Reference: Snow College Humanities Building Addition
DFCM Project No. 05007700

Subject: **Addendum No. 1**

SNOW COLLEGE
HUMANITIES BUILDING ADDITION

ATTACHED DRAWING #AD101

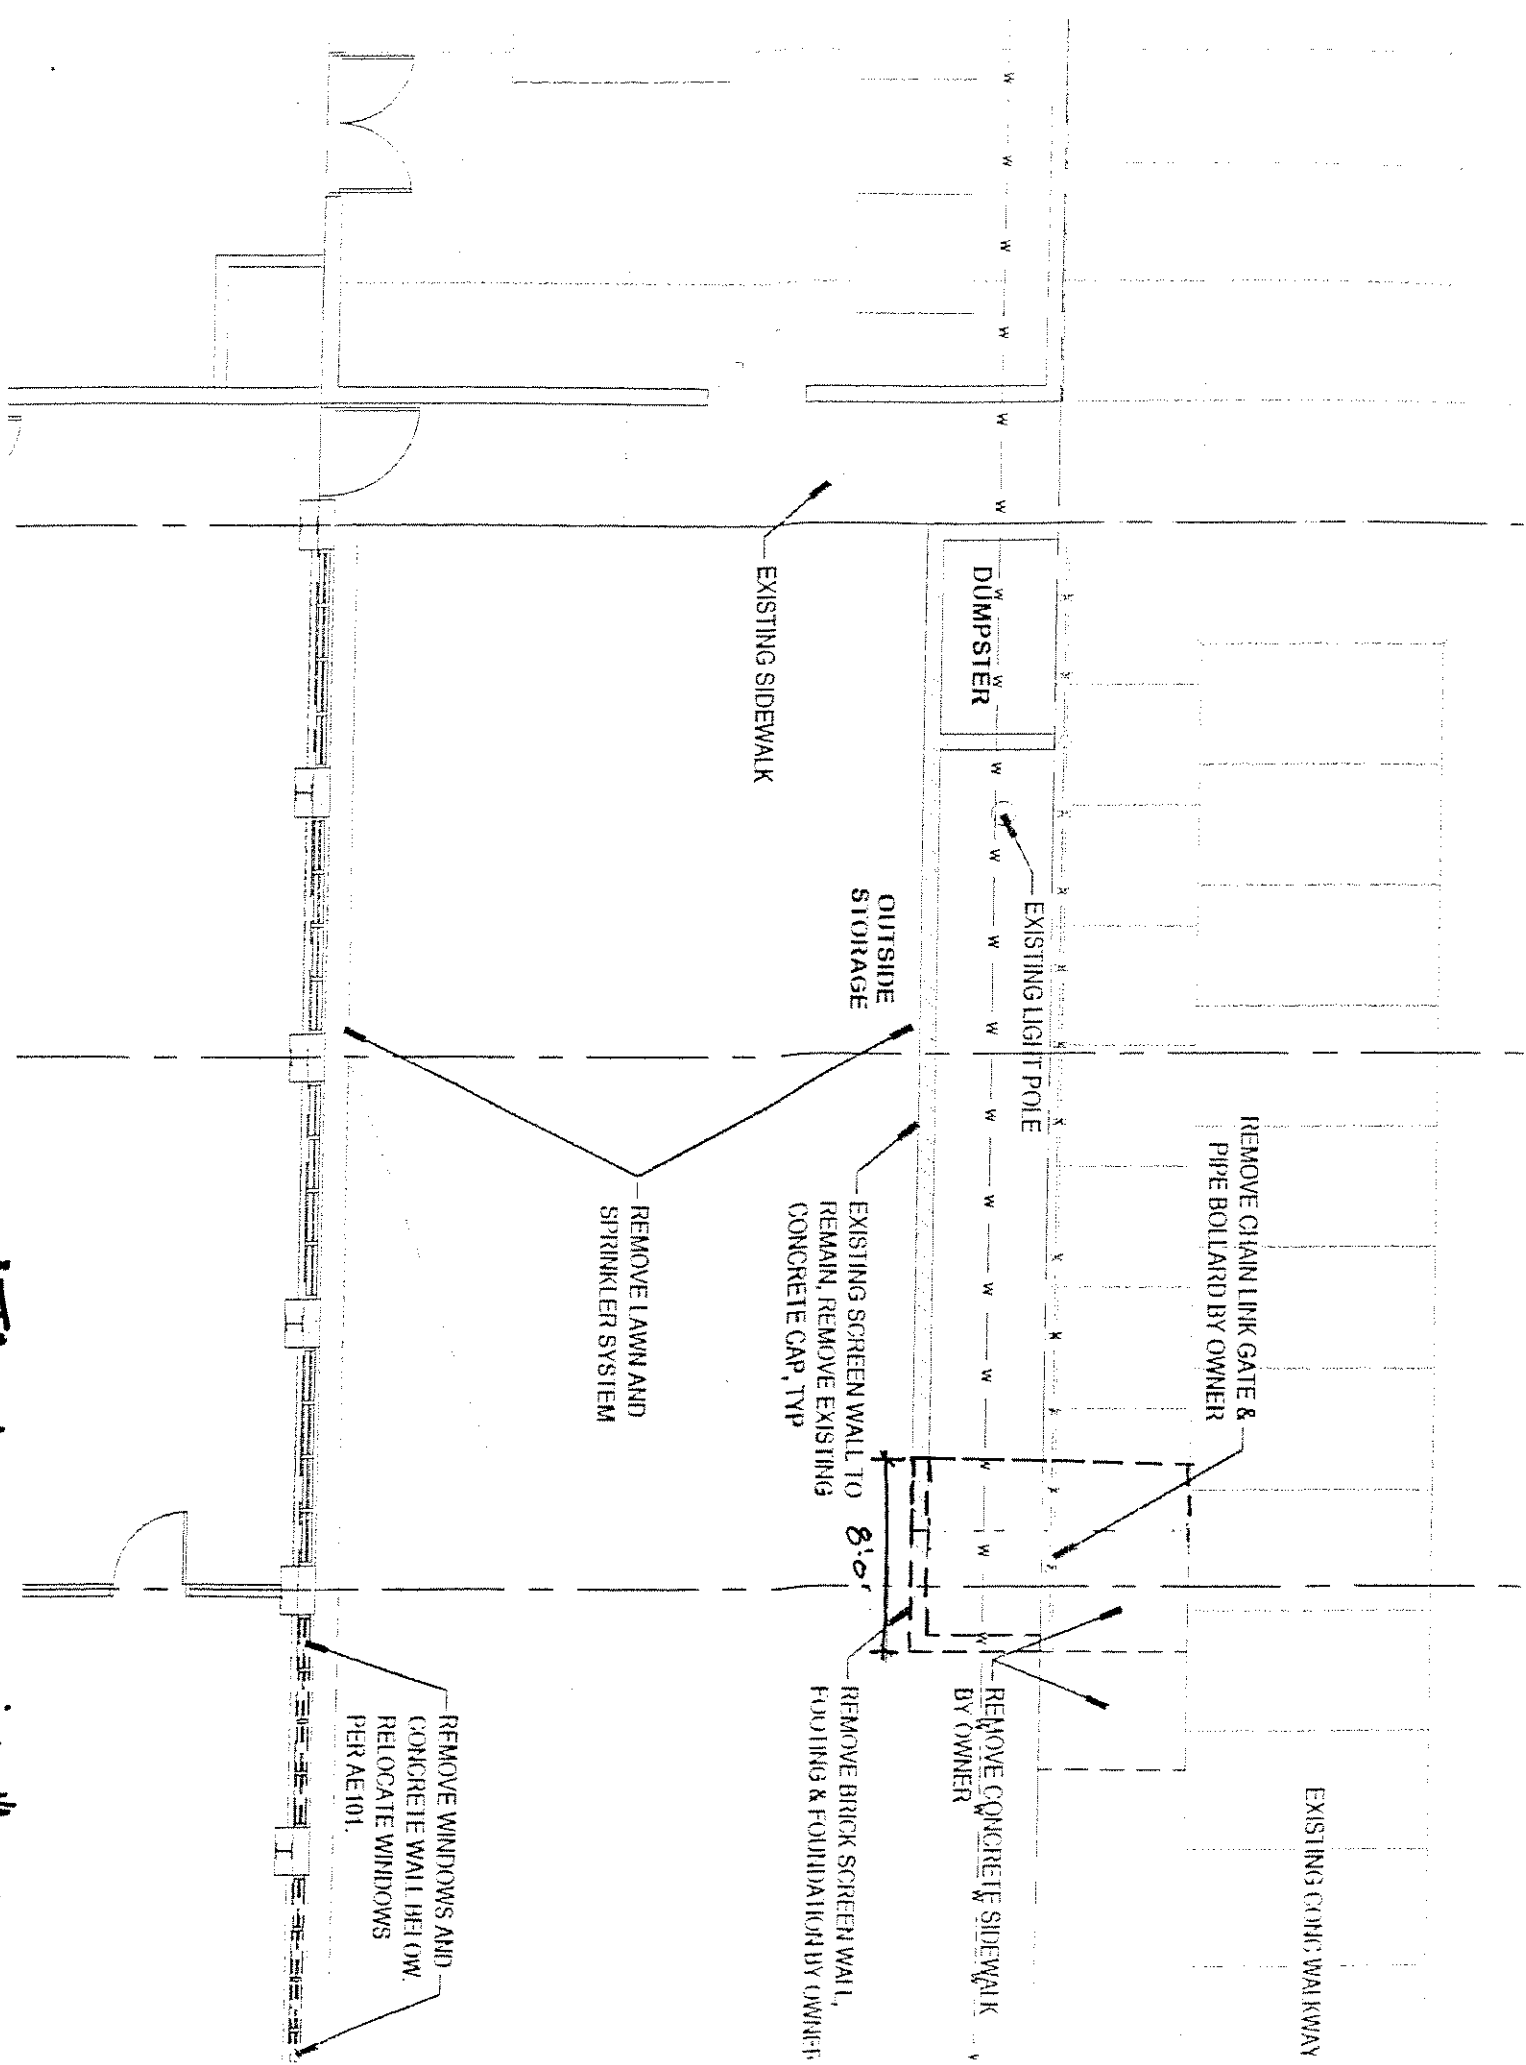
<u>Item</u>	<u>Description</u>
1.1	DEMOLITION PLAN AD101 <ul style="list-style-type: none">• Delete note to have "light pole relocated by owner."• Remove brick screen wall, footing, foundation and concrete sidewalk 8'-0" from south endSee Attached Drawing #1

A6 DROP CORD DETAIL
NTS

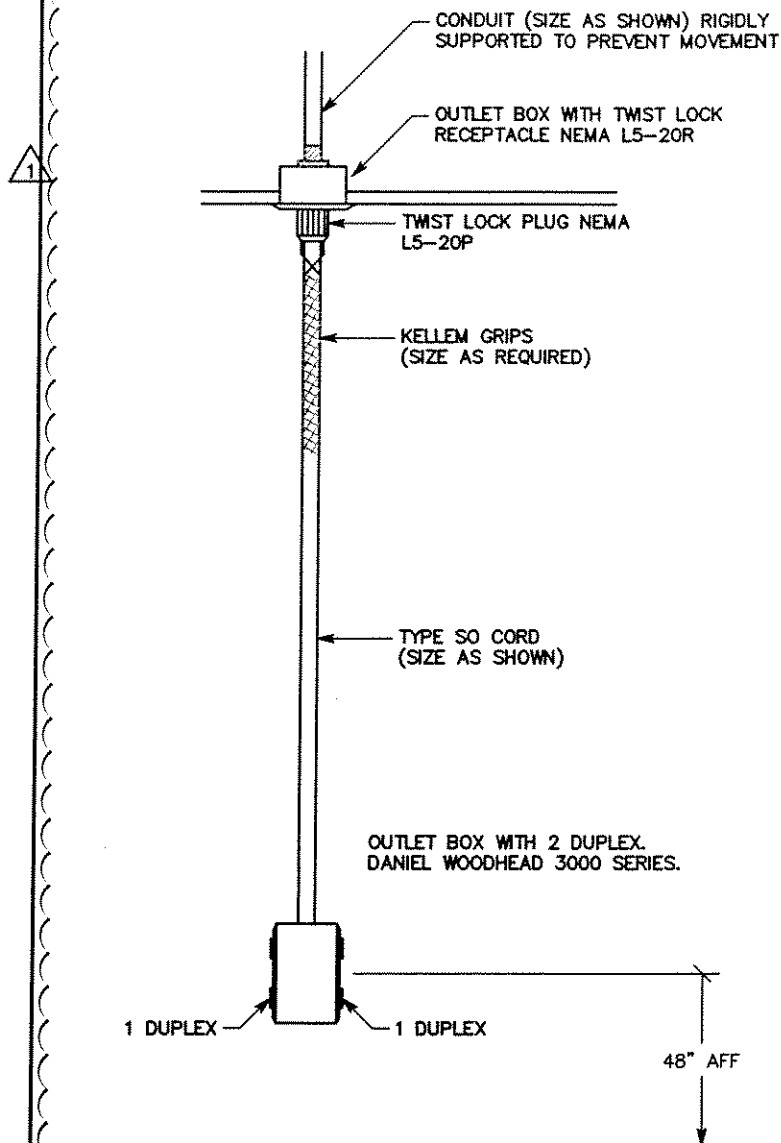
1. Add the attached drop cord detail to this sheet.
